Engineering Change Notice(ECN)

ECN-D-2602-05

(ADDITION OF L-AXIS SENSOR CABLE SIDE MOUNT)

적용 장비 타입 Applicable project type	NEW 12CH HIZ PROCESS [328-21417, 328-21619]	적용 범위 Scope	■ 신규 발주분 (New order) ■ 기발주분 (Previous order) □ 기출하장비 (Existing shipped equipment)
변경 사유 Reason for change	□ 고객 요청 (Customer request) ■ 품질개선 (Quality improve) □ 원가절감 (Cost reduction) □ 생산성 향상 (Increase productivity) □ 부품 단종 (Part discontinuation) □ 기타 (ETC)	ECR NO.	N/A
		ECN NO.	ECN-D-2602-05
변경 상세 사유 Detailed reason for change	ADDITION OF L-AXIS SENSOR CABLE SIDE MOUNT		
변경 사항 Changes	변경 전(Before)	변경 후(After)

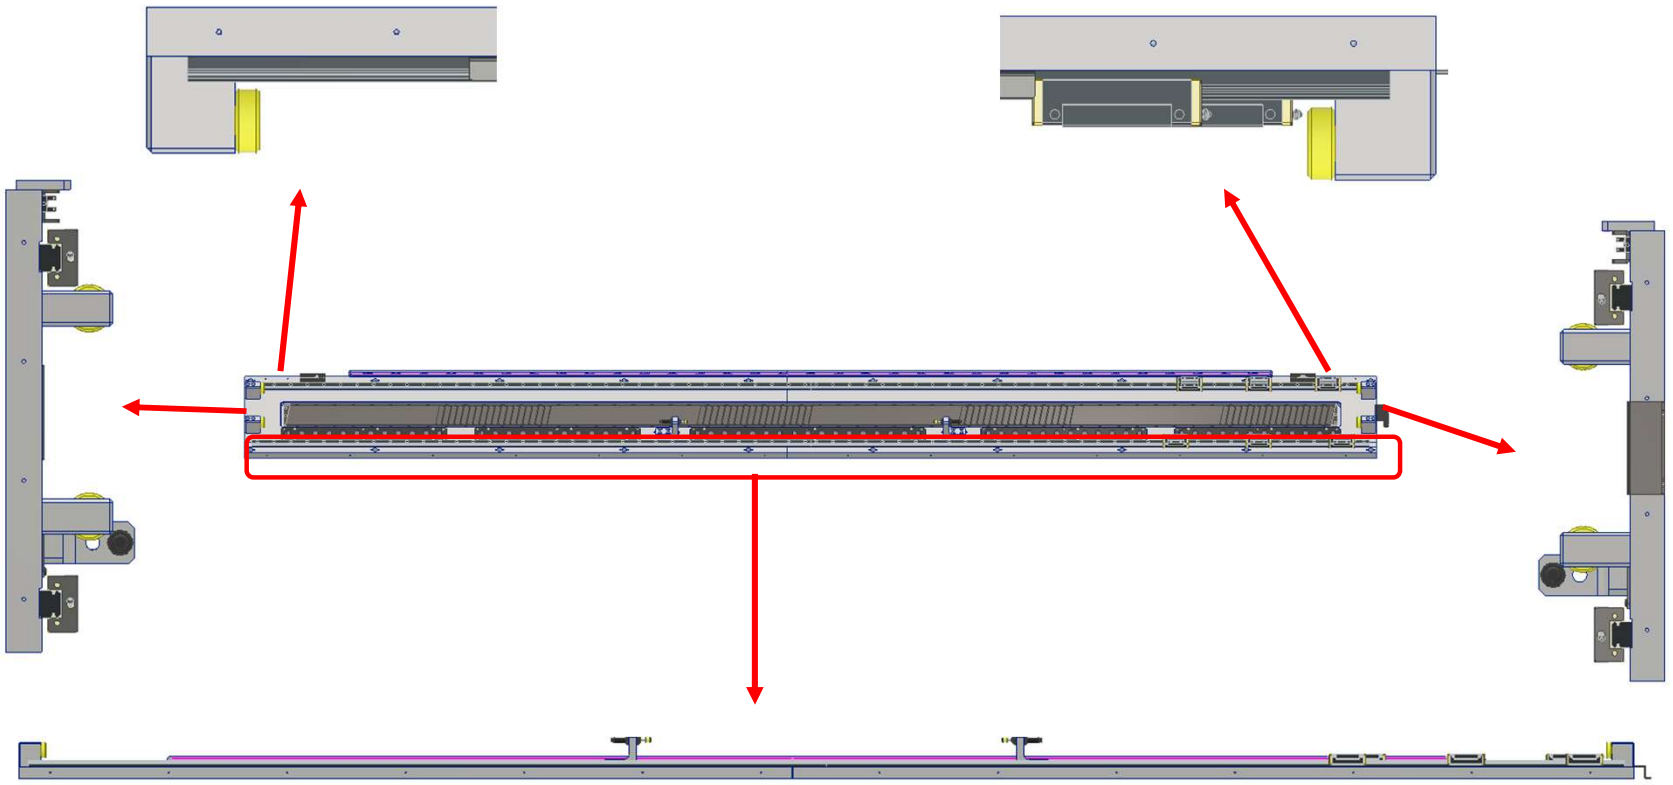
상세내용 Detail	- Part No : CM21P-L000-M001-1 CM21P-L000-M002-1	Add Mount taps 26EA Part No : CM21P-L000-M001-3 CM21P-L000-M002-3

Part No.		
Before	→	After
CM21P-L000-M001-1	→	CM21P-L000-M001-3
CM21P-L000-M002-1	→	CM21P-L000-M002-3
	→
